**Illinois Tollway Standard Drawings Revisions**

| Section L    |   | Fiber Optic           |  |
| Standard     | Modification Summary  | Effective: 03-01-2025 |  |
| <b>L1-07</b> | <b>Fiber Optic System Typical and Drawings</b>  |                       |  |

VERSION: 2025-03      STANDARD: L1-07      SHEET: 9 OF 15

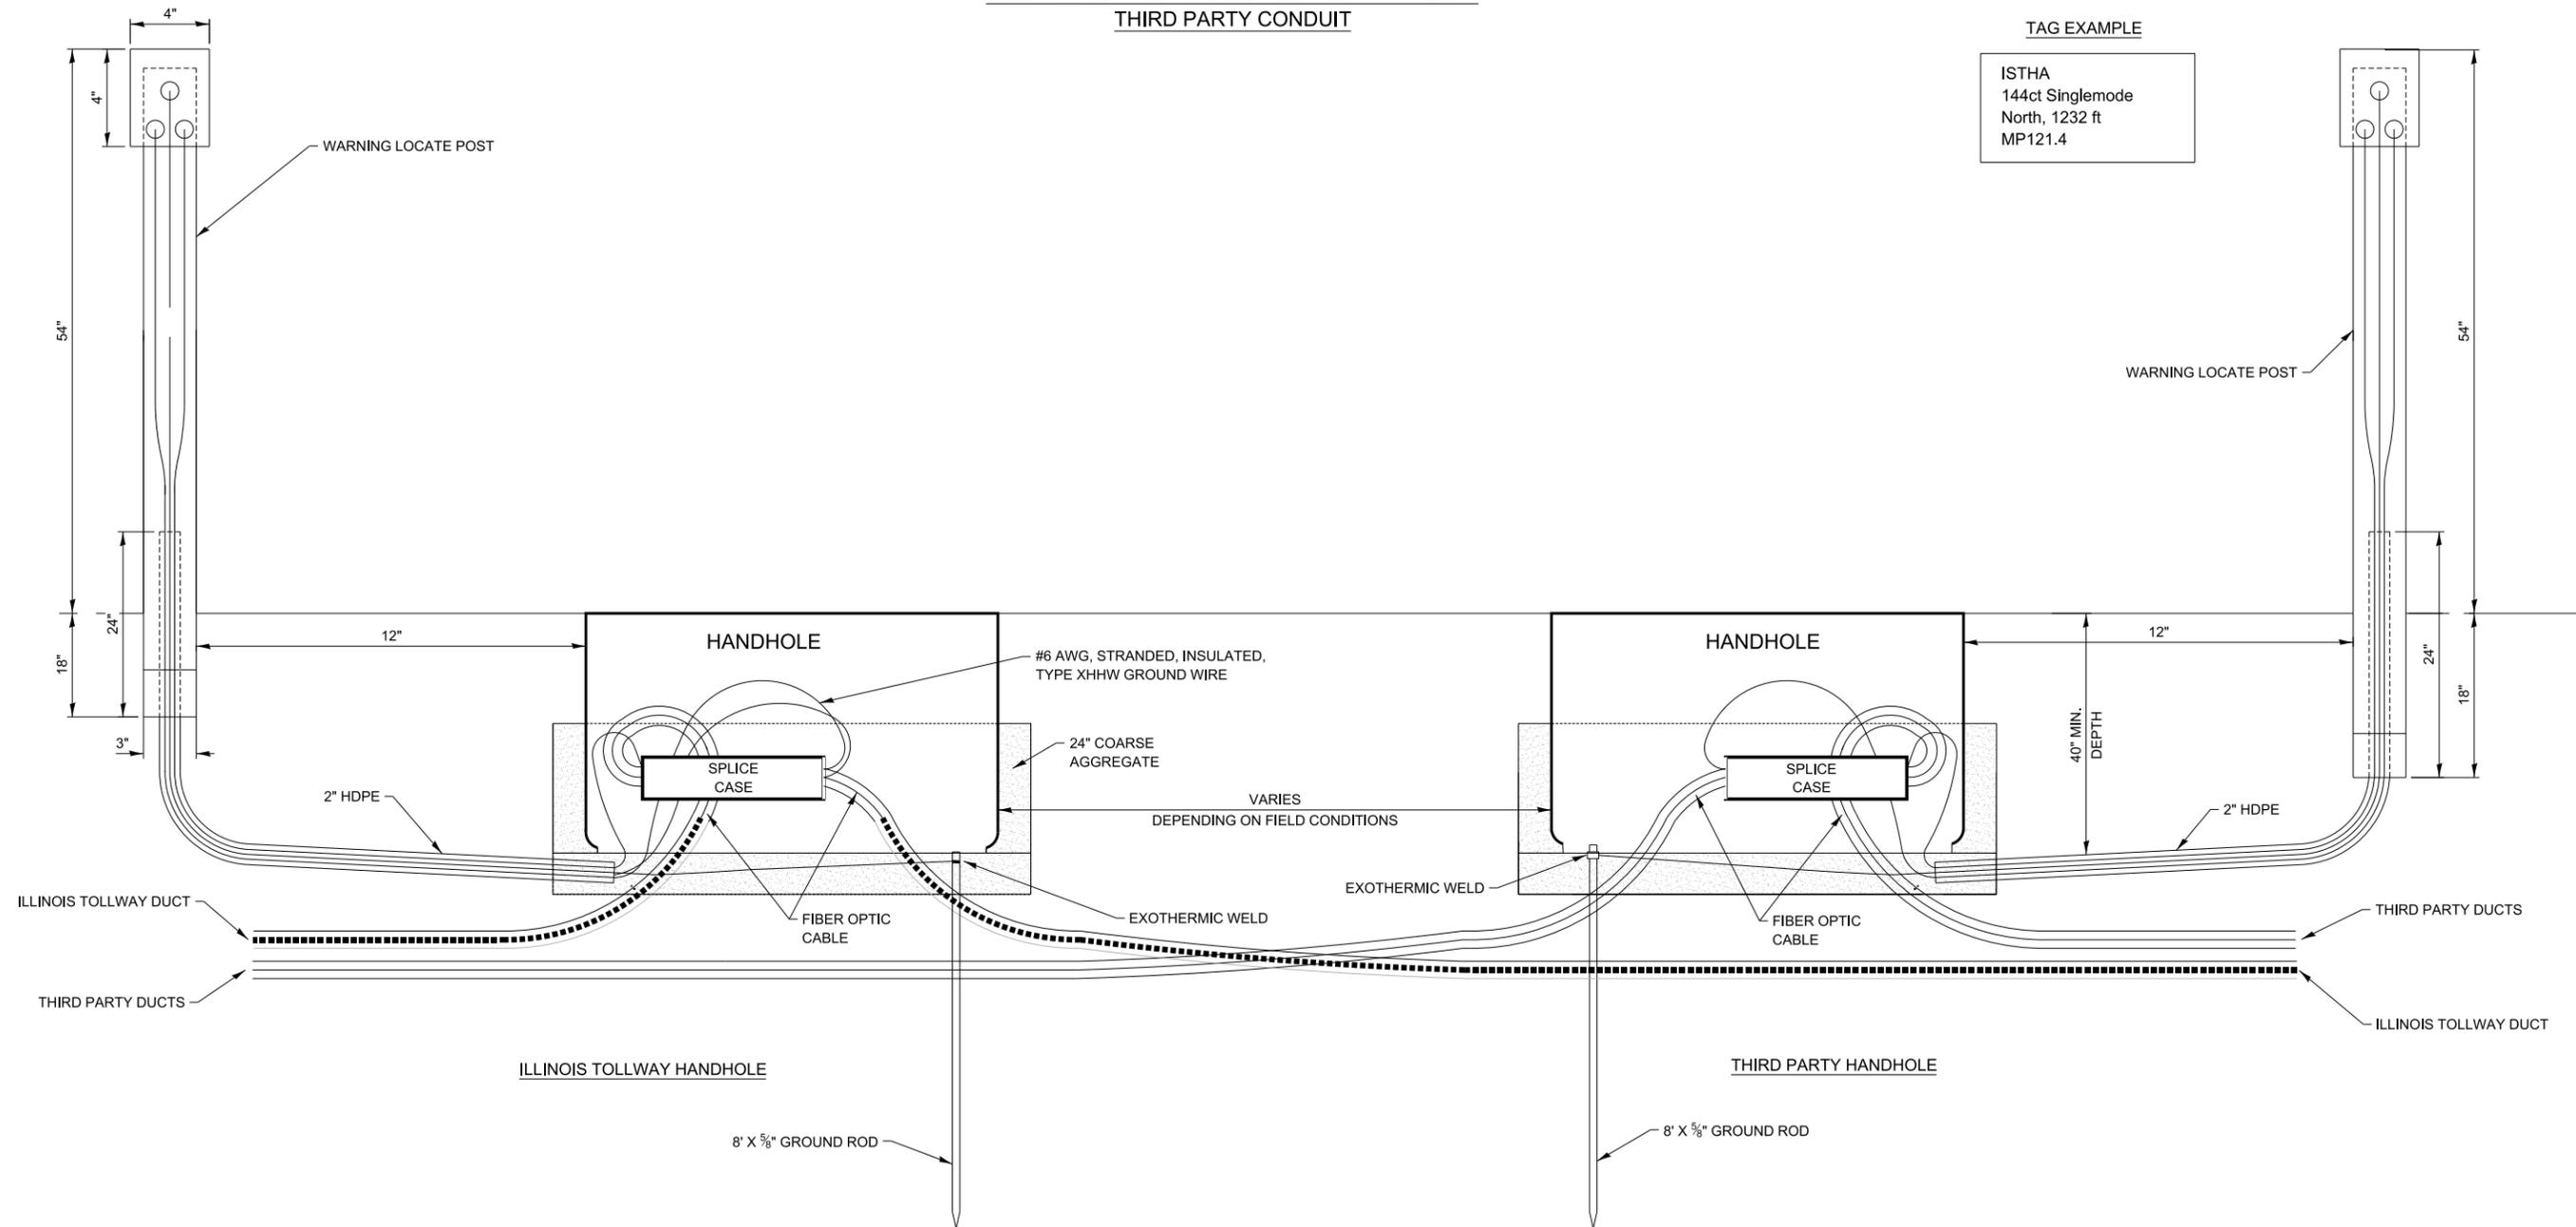
| Section L    |   | Fiber Optic           |  |
|--------------|---|-----------------------|--|
| Sheet 9      | Removed note that stated "manufacturer's specifications of minimum bend supersede Table A".   |                       |  |
|              | Removed "containing a splice enclosure" from Note 8.  |                       |  |
|              | Change "pea gravel" to "coarse aggregate" in the "Locate Warning Post" detail.  |                       |  |
|              | Updated "Locate Warning Post" detail to show the ground rod being flushed to the bottom of handhole.  |                       |  |

| Section L |   | Fiber Optic           |  |
|-----------|---|-----------------------|--|
| Sheet 9   | Inserted "at maximum, 3ft away from..." to Note 1.  |                       |  |
|           | Inserted "displaying milepost..." to Note 12.   |                       |  |
|           | Added Note 14.  |                       |  |
|           | Changed "solid" to "stranded" in the callout of the "Box and Cover Section" detail.   |                       |  |
|           | Changed "#8" to "#7" on the "Box and Cover Section" detail.   |                       |  |

VERSION: 2025-03      STANDARD: L1-07      SHEET: 10 OF 15

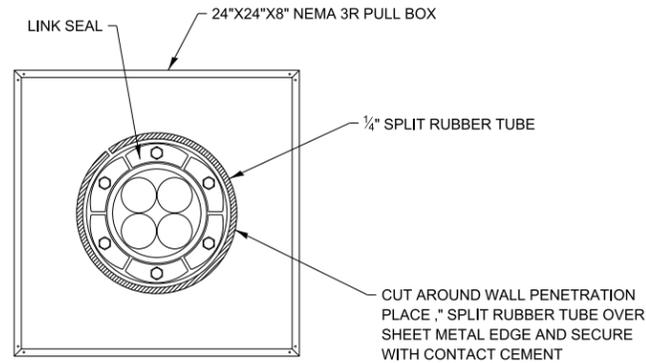
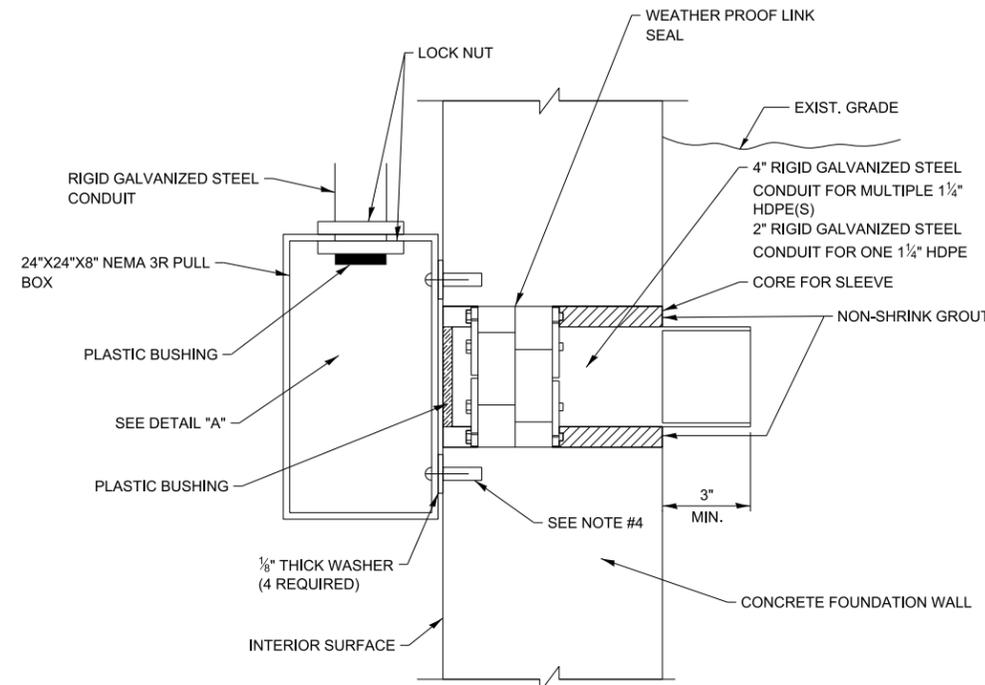
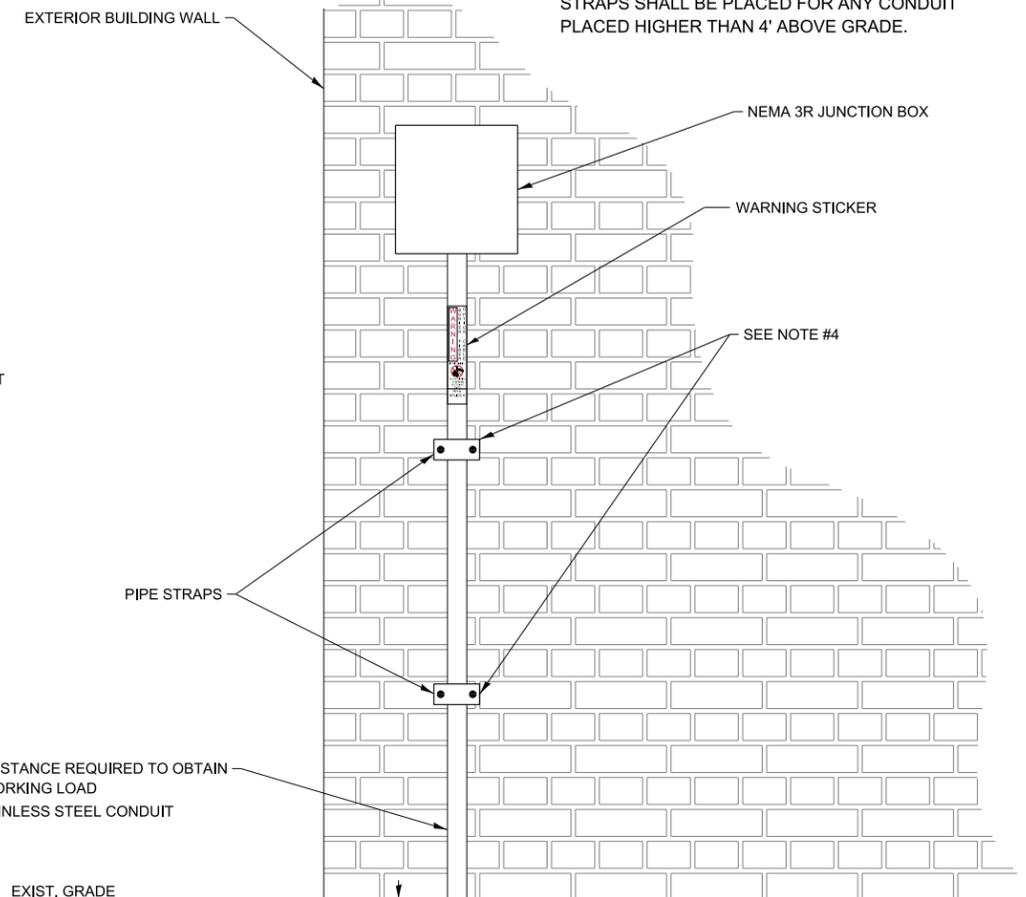
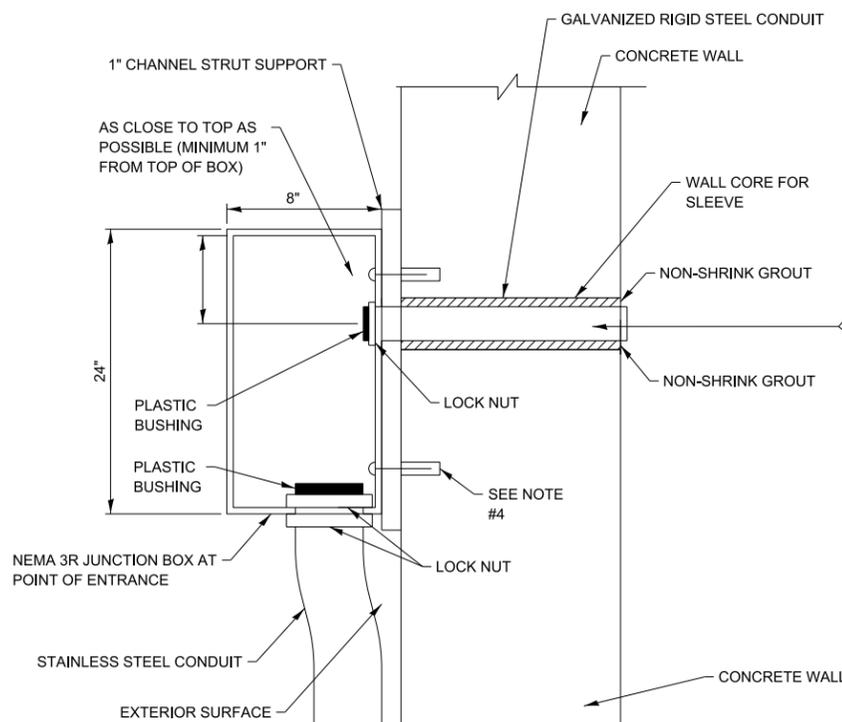
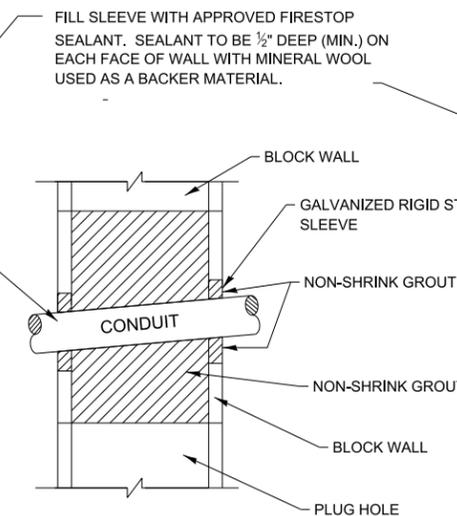
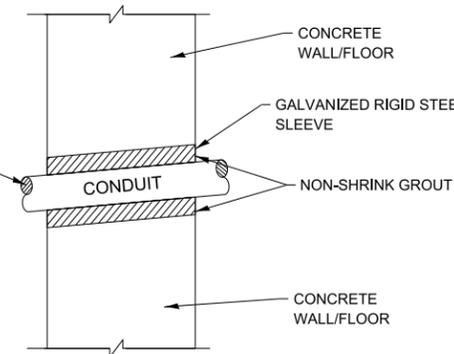
| Section L |   | Fiber Optic           |  |
|-----------|---|-----------------------|--|
| Sheet 10  | Updated measurement from "1-1/4" to "2" on the Box and Cover Section detail.  |                       |  |
|           | Inserted "at maximum, 3ft away from..." to Note 1.  |                       |  |

| VERSION:<br>2025-03 | STANDARD:<br>L1-07 | SHEET:<br>12 OF 15 |

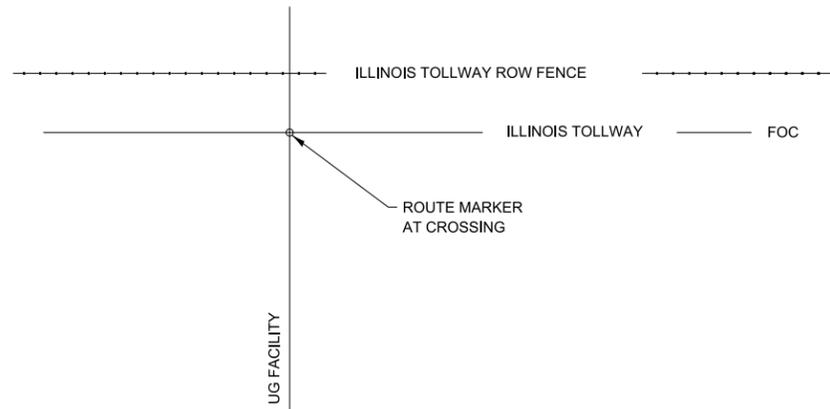
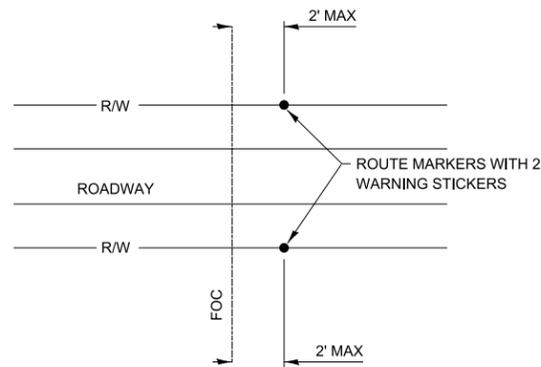
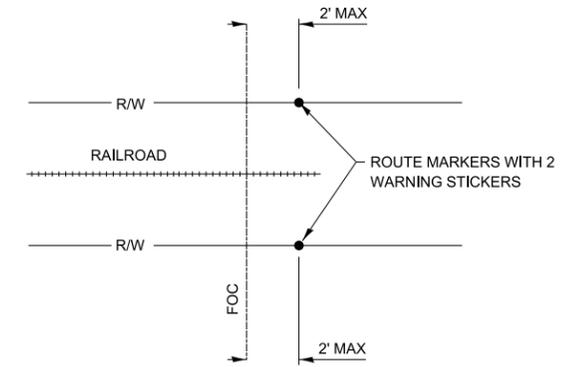
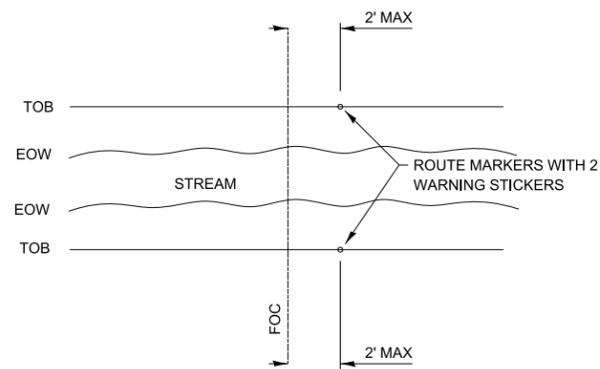
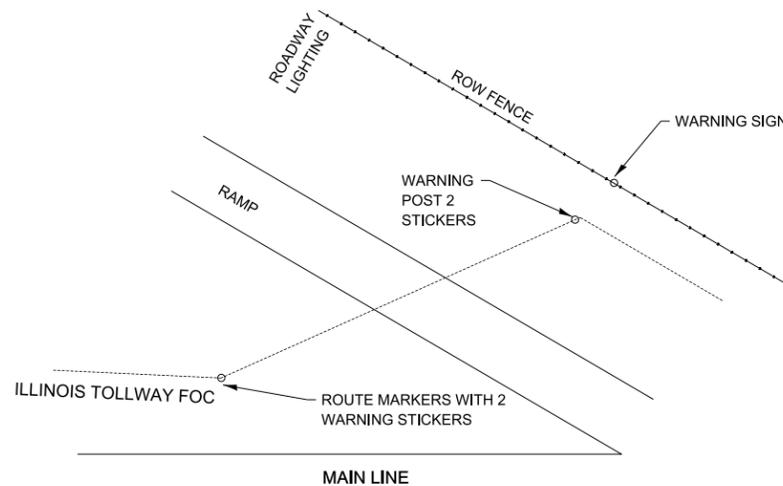
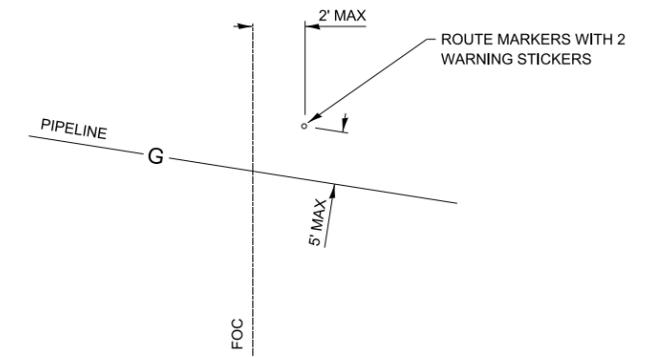
| Section L |   | Fiber Optic           |  |
|-----------|---|-----------------------|--|
| Sheet 12  | Updated measurement associated to the warning locate post on the "Third Party Handhole" detail to be consistent with the measurement on the "Illinois Tollway Handhole" detail. |                       |  |
|           | Replaced "stainless steel" with "galvanized rigid steel" in Note 1.   |                       |  |
